FIXED BEAM ANCHOR - INSPECTION NOTICE (FOR SALT-WATER/CHLORIDE/SULFIDE ENVIRONMENTS)

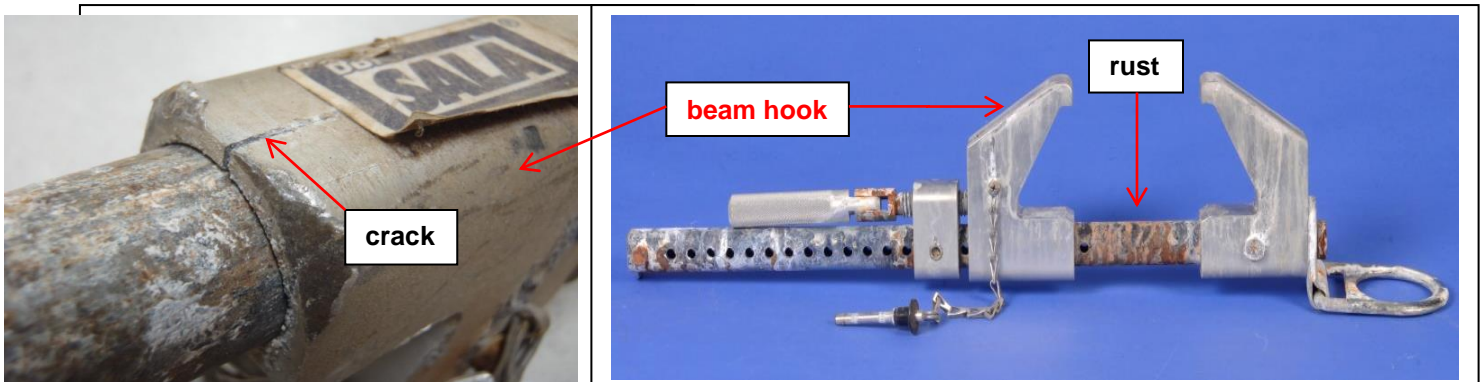
Capital Safety has become aware that the service life of the beam hooks identified in the images below (in red font) may be impaired by stress corrosion cracking when the anchor is exposed to salt-water or other chloride or sulfide-containing environments.

- 1) have the units visually inspected by a competent person; and
- 2) if **any** corrosion, pitting or cracking is found on the beam hooks or the support tube (see illustrations below), remove the unit from service and return via your supplier/distributor to Capital Safety for evaluation and potential replacement under warranty at Capital Safety's reasonable discretion and expense.

Illustrative images: cracks or rust may look different or be in different locations

- 3) if **no** corrosion, pitting or cracking is found on the beam hooks or the support tube, the units are safe to remain in service provided they are inspected every 90 days and removed from service if **any** corrosion is found anywhere on the unit.

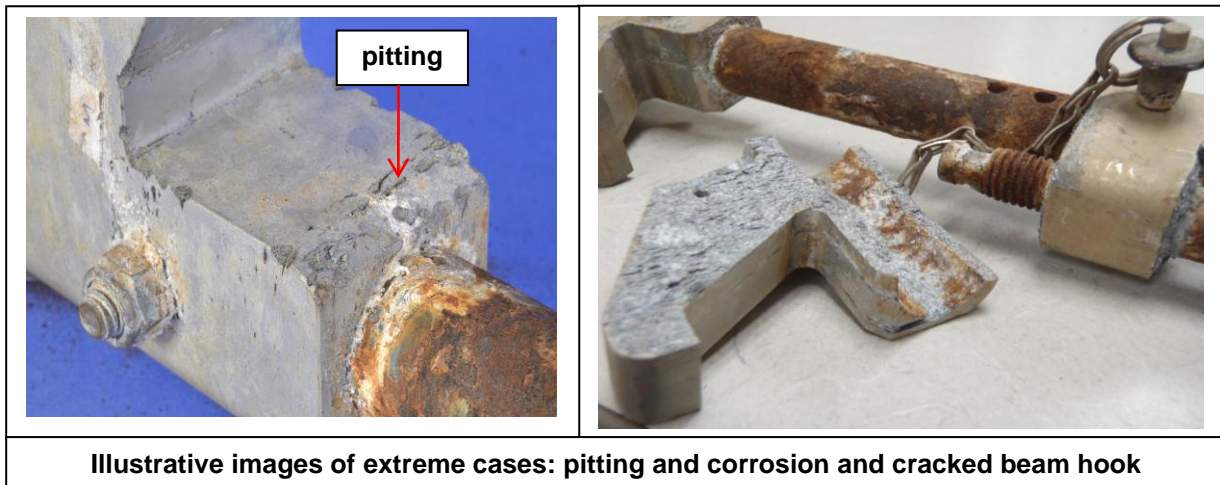
In extreme cases, the integrity of the beam hooks can be severely compromised to the point of failure by stress corrosion cracking as seen in the photographs below:

Since becoming aware of this issue, Capital Safety has changed the metal alloy of the beam hooks to make them resistant to stress corrosion cracking in salt-water or other chloride or sulfide-containing environments.

Capital Safety has also revised section 5.0 of its manual on Inspection as follows: **“5.3** If inspection reveals an unsafe or defective condition remove unit from service. **IMPORTANT:** Any observed corrosion or rust on the anchor is a potential safety concern because it can weaken the product and create a risk of injury or death to workers. Any anchor showing signs of corrosion or rust should be removed from service immediately.”
